## SSD7500 – Proposed Warehouse and Logistics Hub, 5 and 9 Culverston Road, Minto – Response to Submissions – Flooding and Stormwater

**Additional Flood information - 5 Culverston Road, Minto**

Location Map

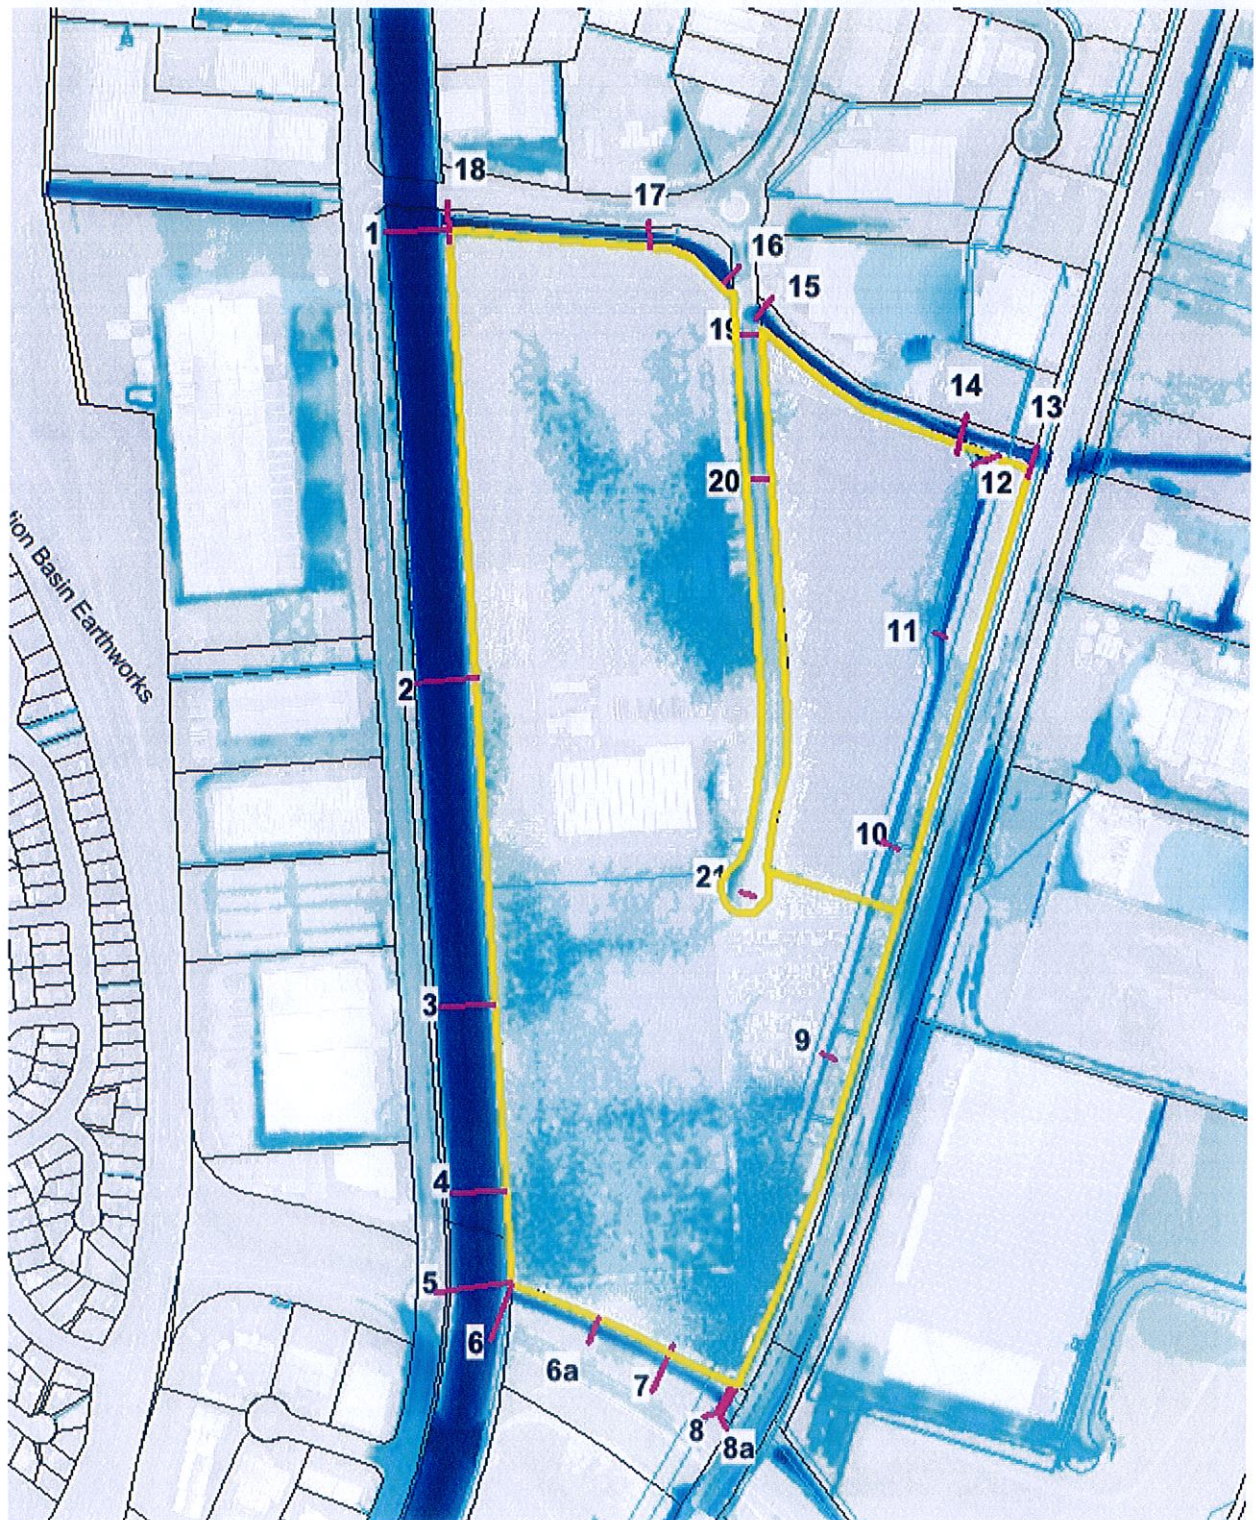
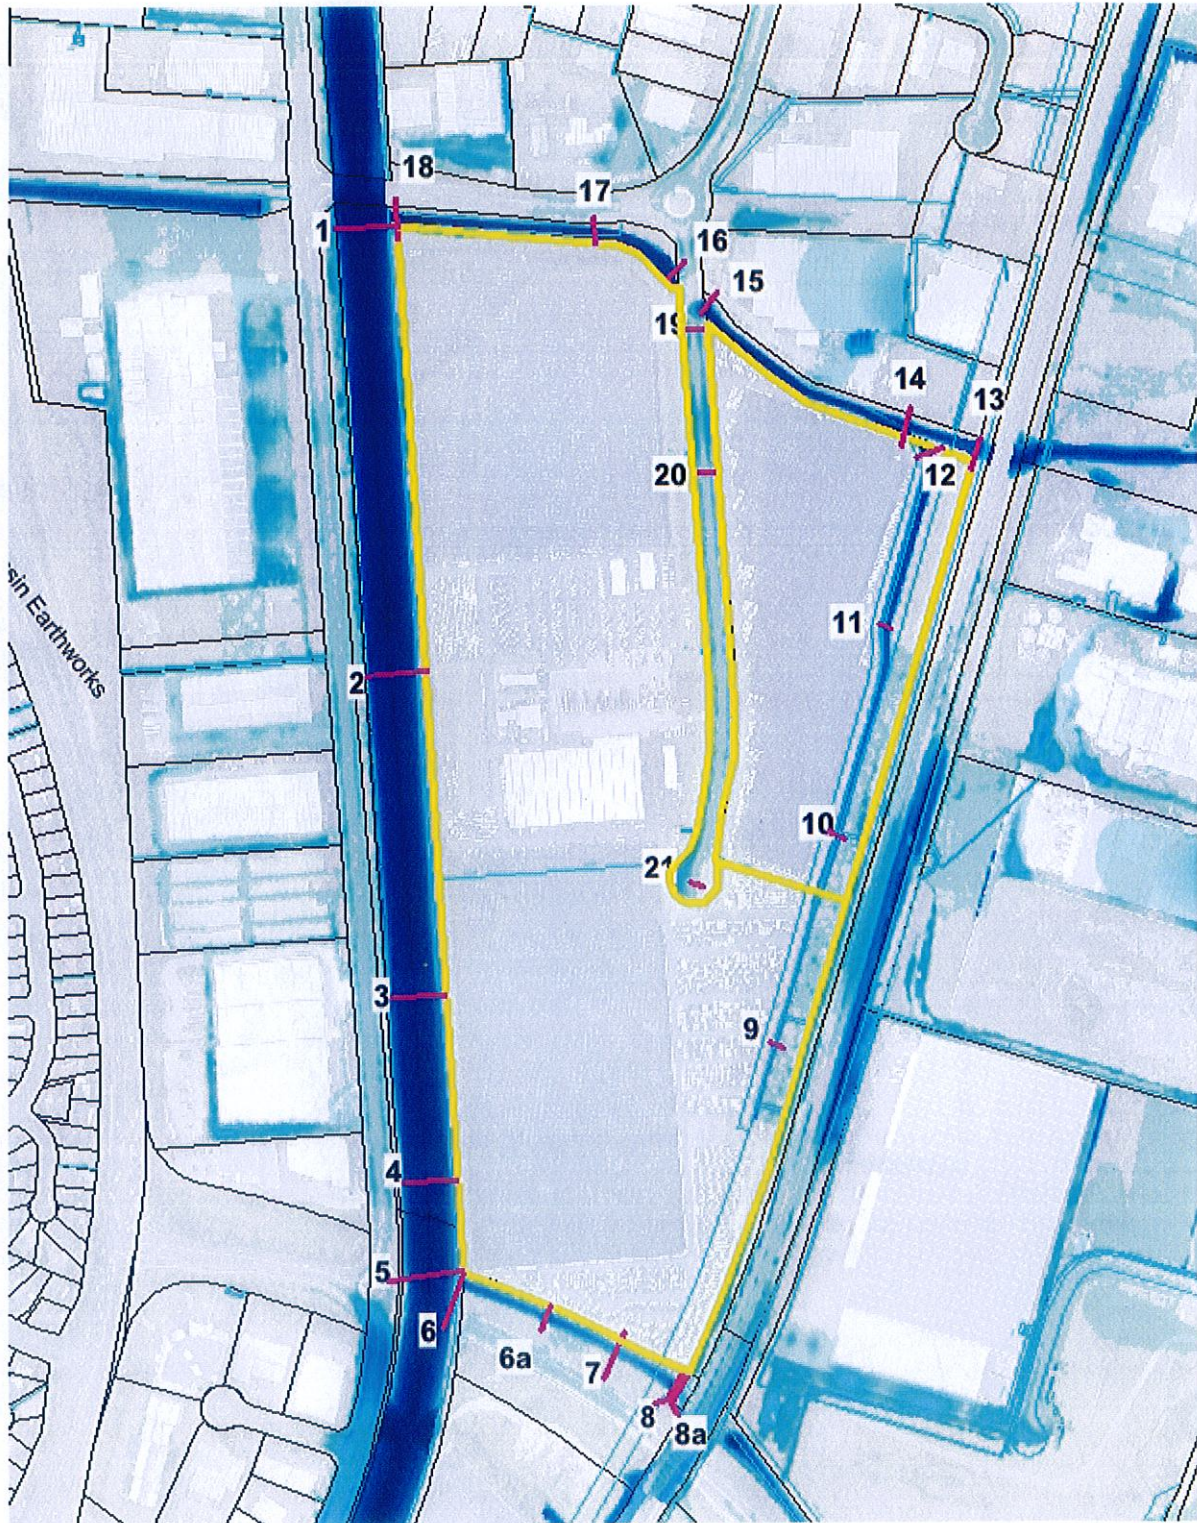
1. Council's consultant has reviewed the flood information for the above site as requested for the following scenarios and summary of the flood levels given on the attached table (page 2). Also attached a location map for your reference (page 3).
  - a. Existing topographic and development conditions.
  - b. Raise only the development site by 10m above the current levels.
2. It is noted that there is only marginal change in flood levels in the vicinity of this site between above 2 scenarios. The differences in flood levels between the fill and no fill are generally small.
3. Please refer to page Nos. 4 and 5 for the flood maps for the exiting topographic condition and raise only the development site by 10m.

1% AEP flood levels based on the existing topographic condition (Column 1) and raised the site by 10m (column 2)
